# STERLING RANCH ROAD & BRIARGATE PARKWAY STORM PLANS

COUNTY OF EL PASO, STATE OF COLORADO  
STORM SEWER PLANS  
MAY 2022

# ENG-CDR22001-R3-CDs Storm.pdf Markup Summary

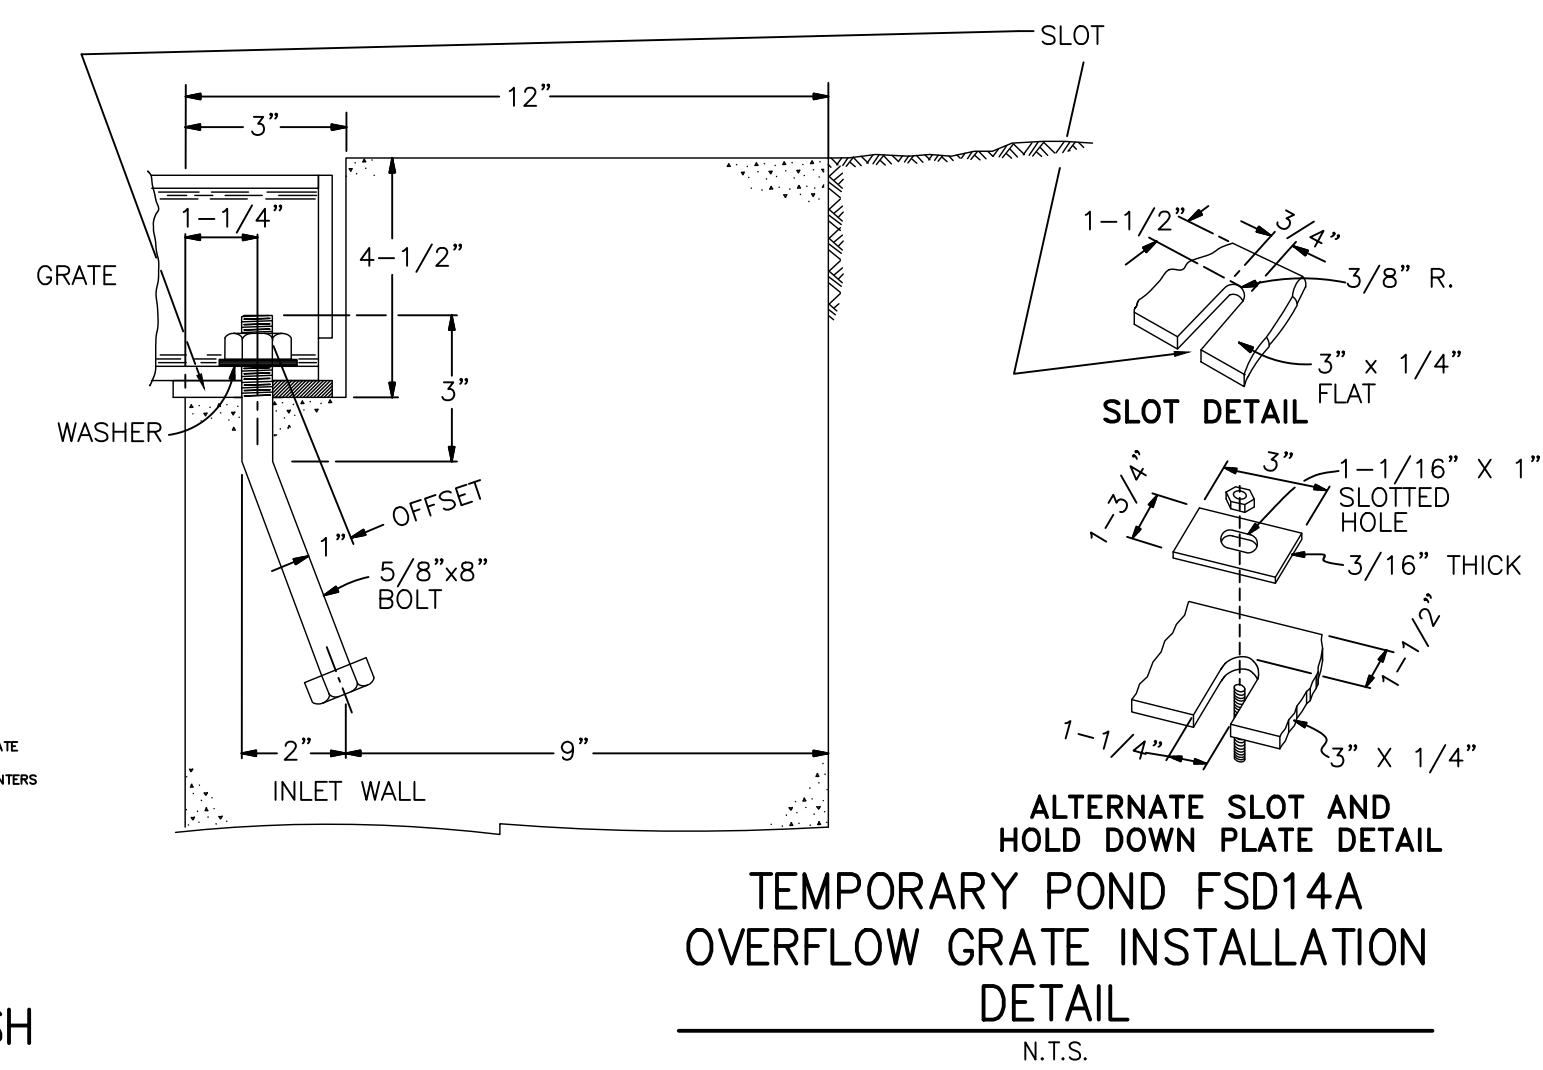
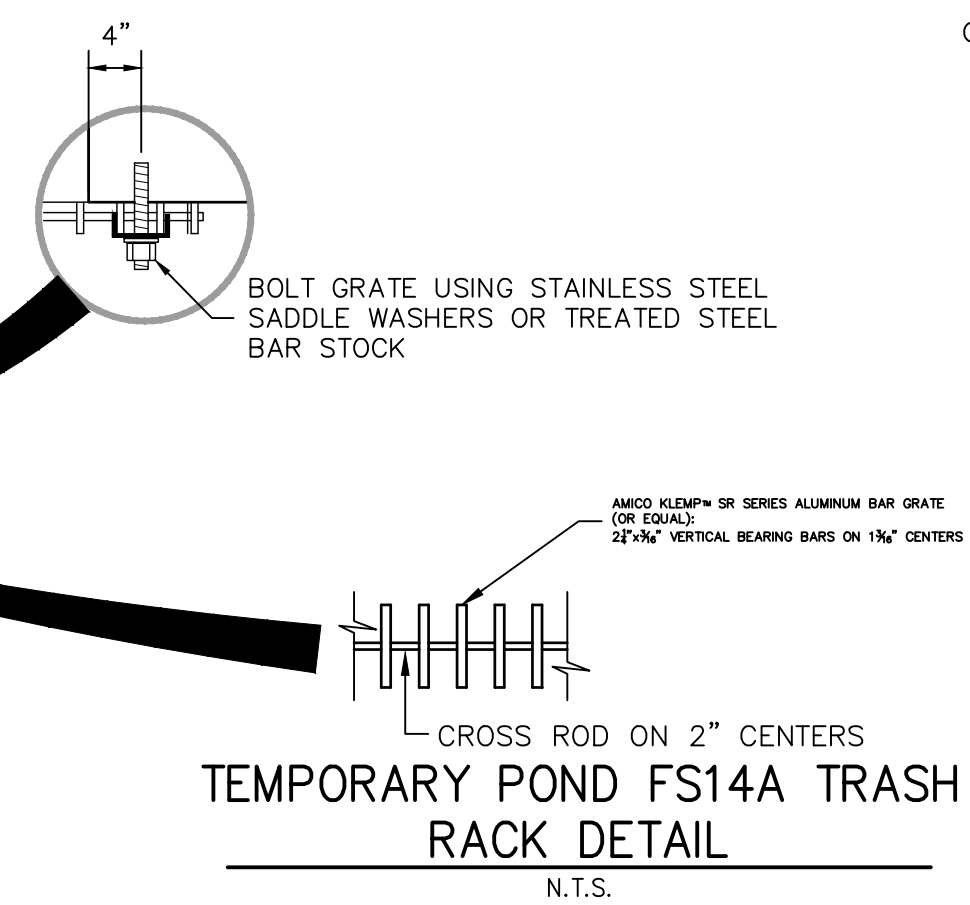
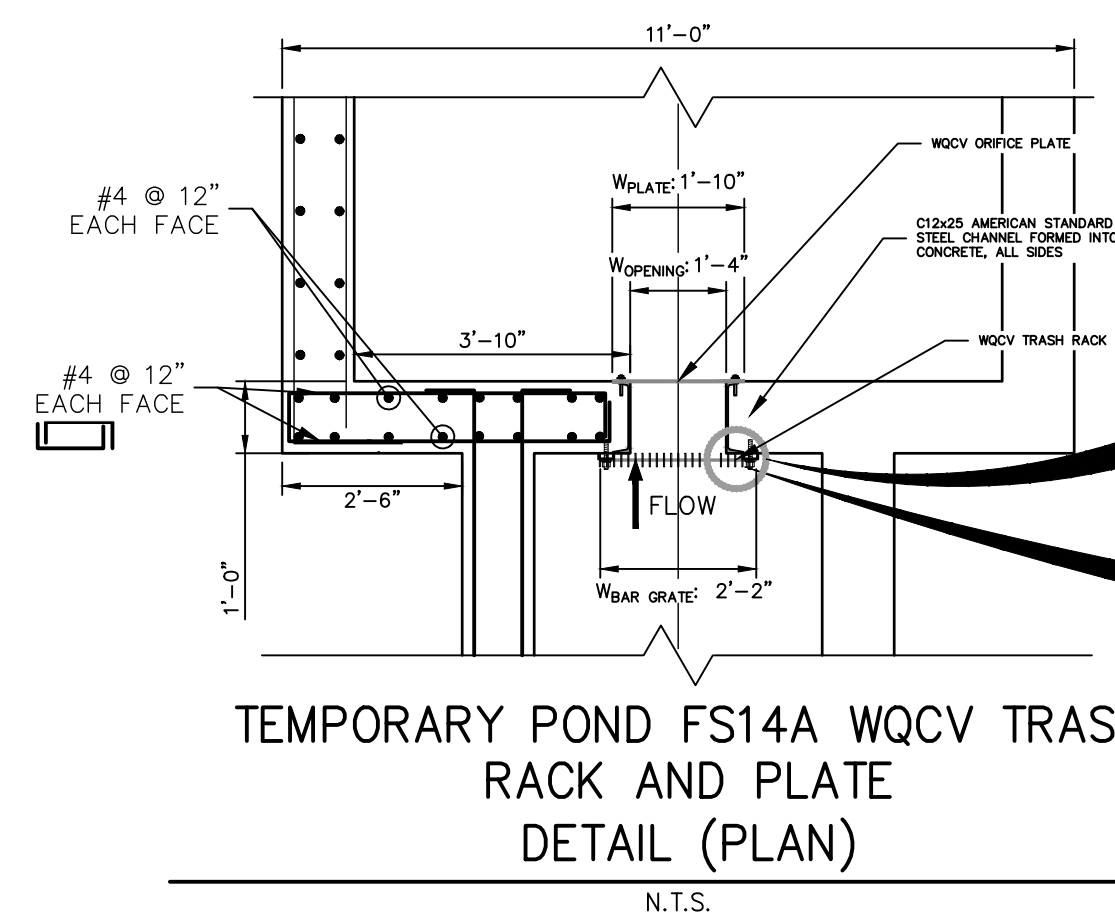
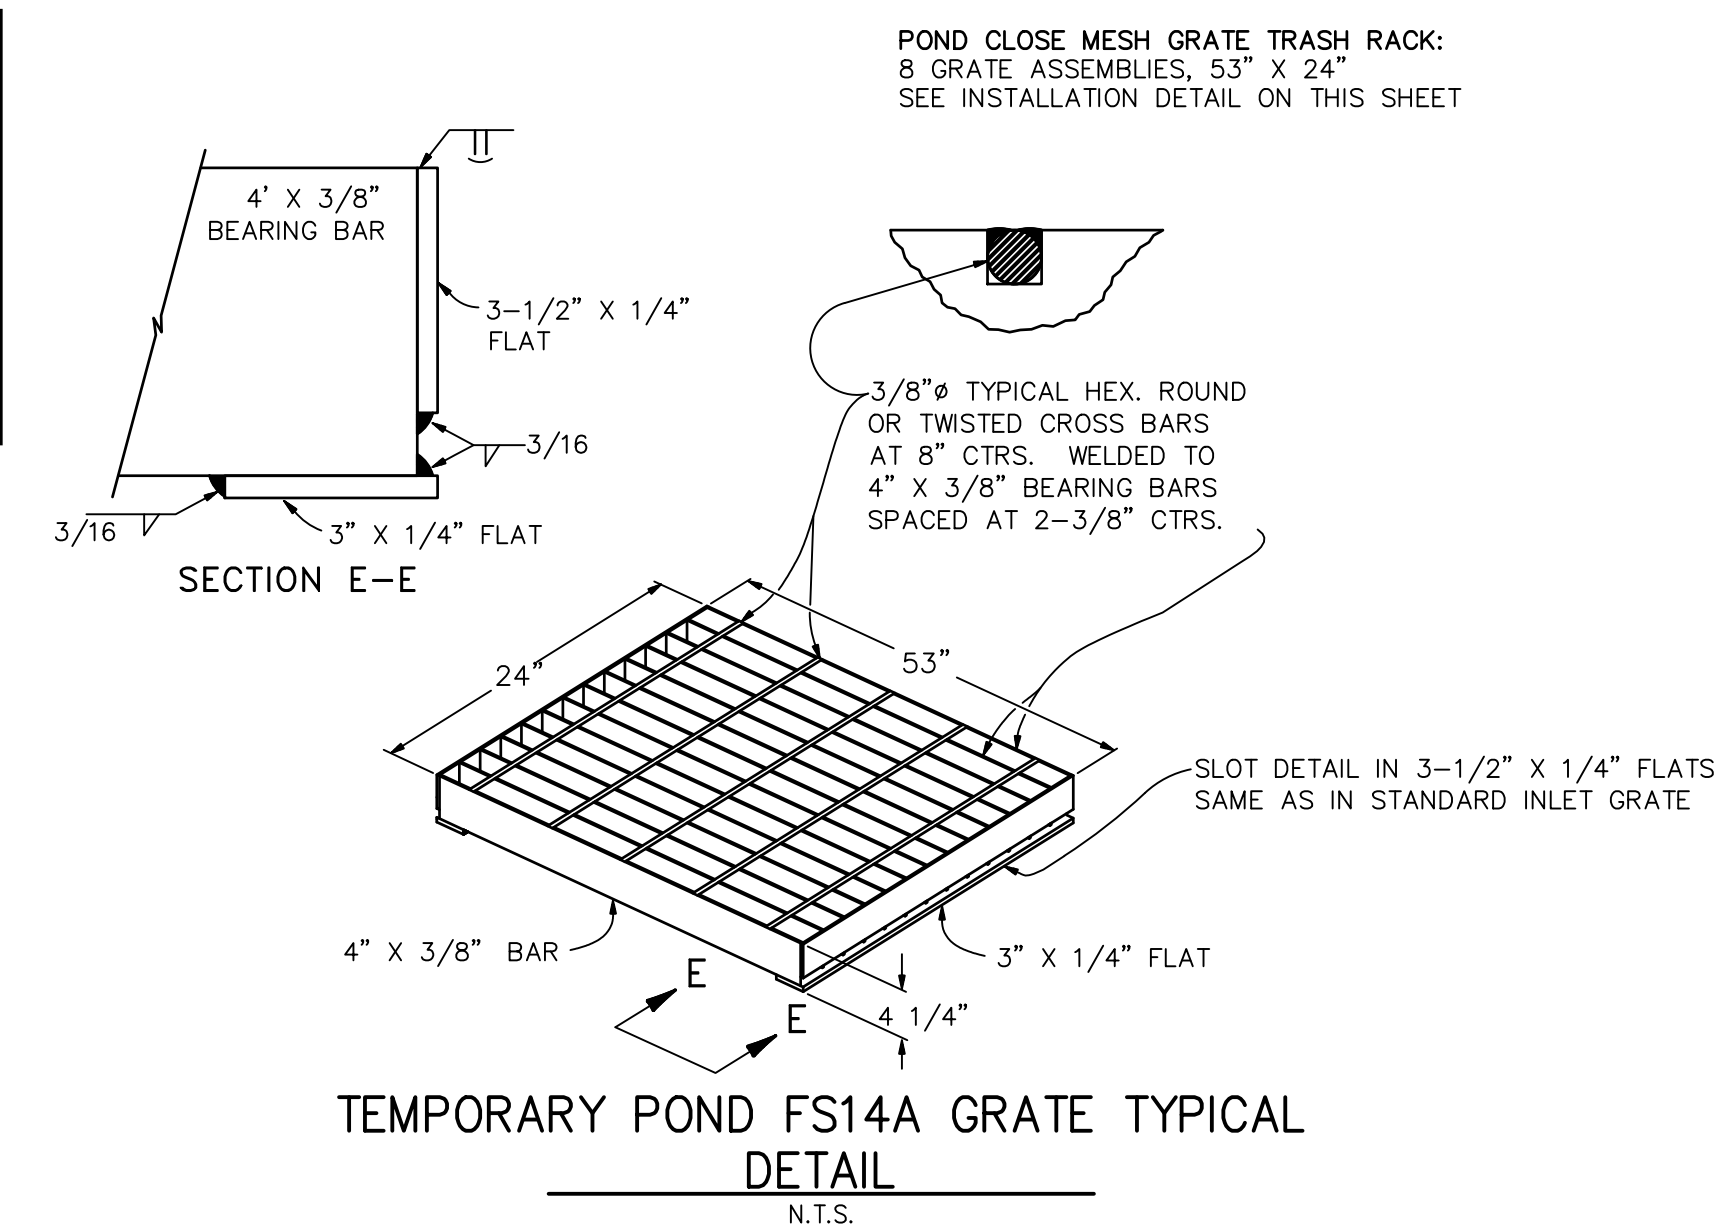
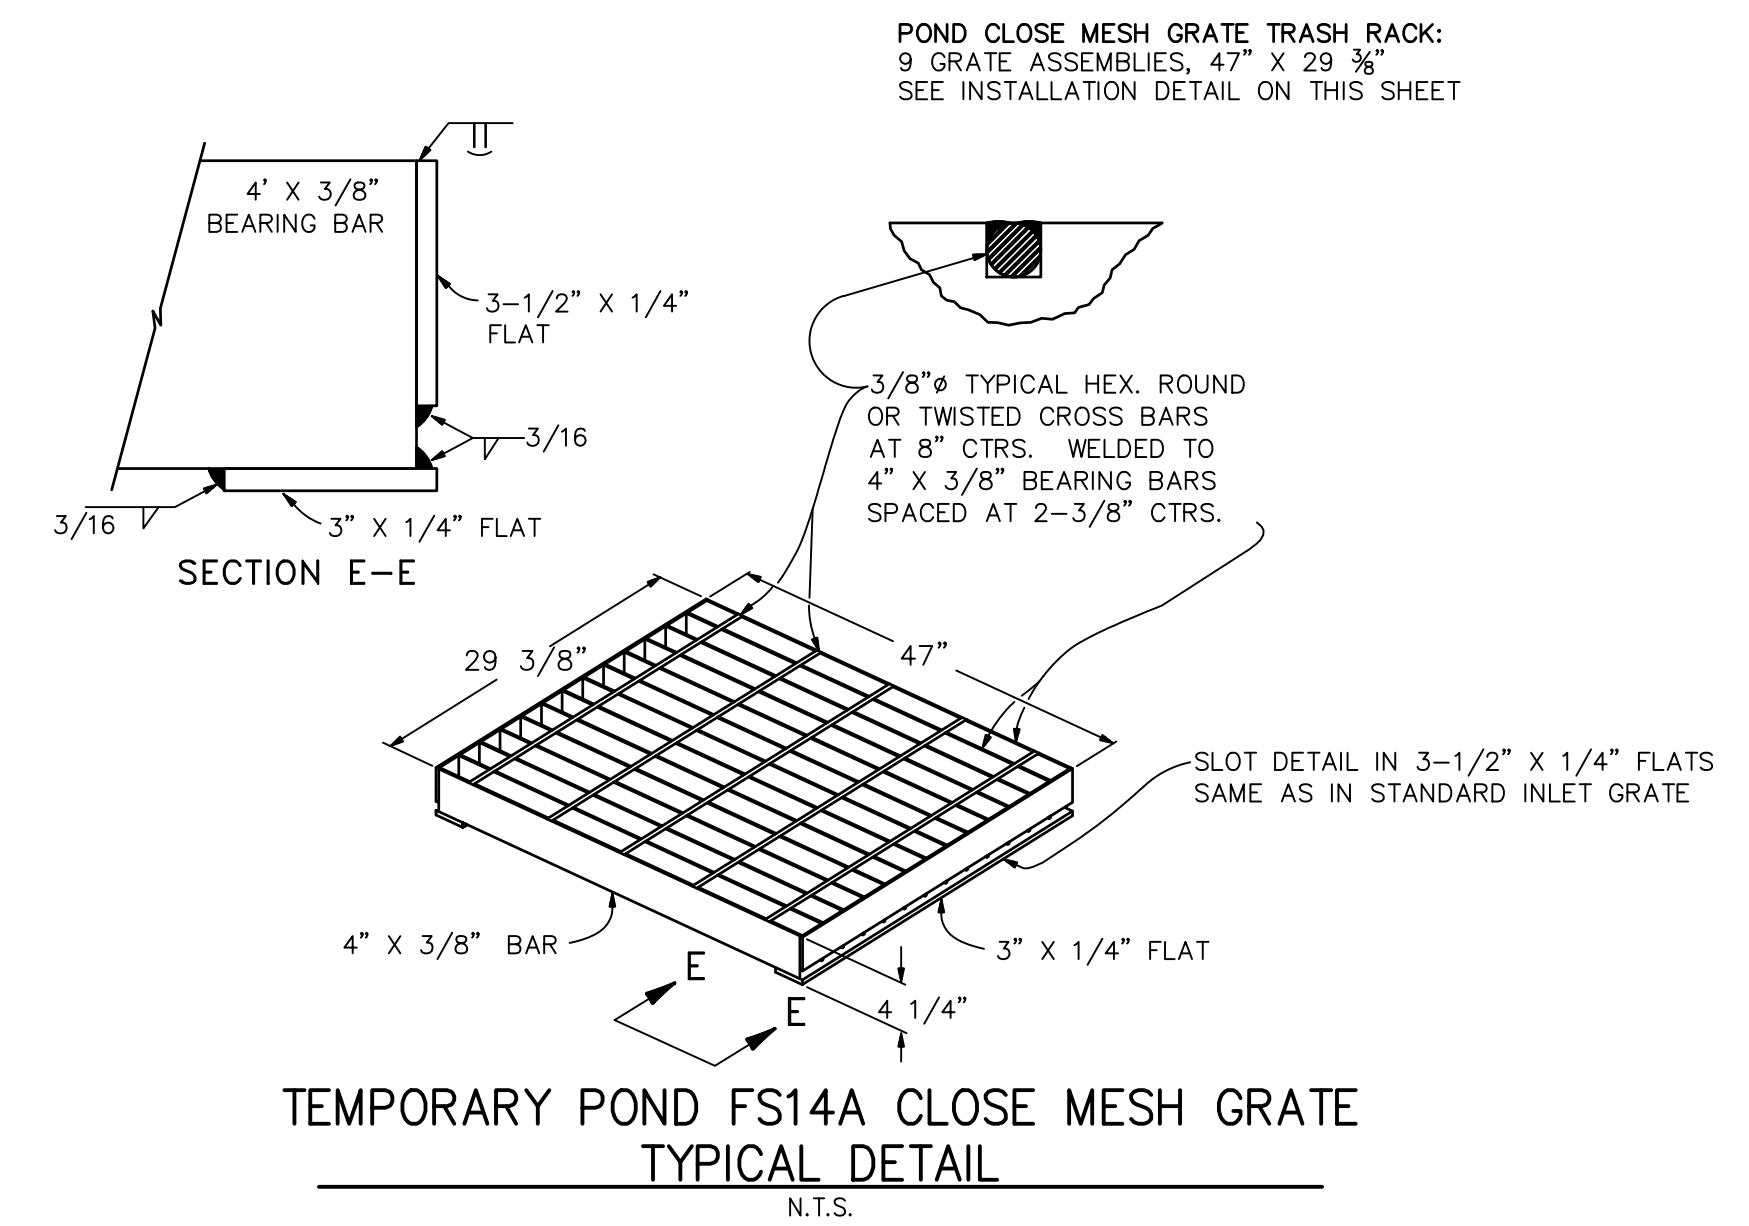
Per meeting with engineer Mike Bramlett on 4/11/2022, we discussed that for this project, only a TSB will be constructed. The subsequent EDB and all associated structures (trickle channel, forebay, outlet structure, etc) will be built with a near-future adjacent project.

So Mike is going to mark this drawing "For Information Only" or remove it from the drawing set entirely.
